**RE:    Comment Response Letter - Initial Submittal – Town Center at Aurora Phase 2**  
**Application Number: DA-1105-17**  
**Case Numbers: 1985-6028-27**

## **COMMENT RESPONSE LETTER: INITIAL SUBMISSION REVIEW**

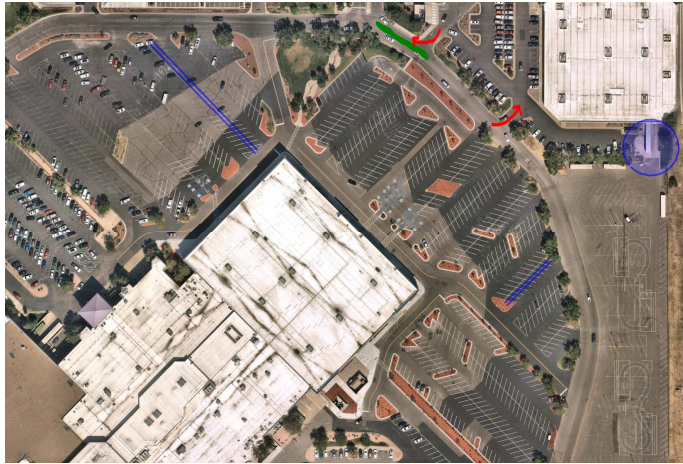
**E. Proximity to transit permits a 30% reduction in required parking for commercial uses. This reduction is not permitted for multifamily uses.**

- *Response: There is ample parking here for the entire mall with the shared use agreement. We were asking for a 100% reduction in the parking study. We are not adding any new parking for the Phase 2 development.*
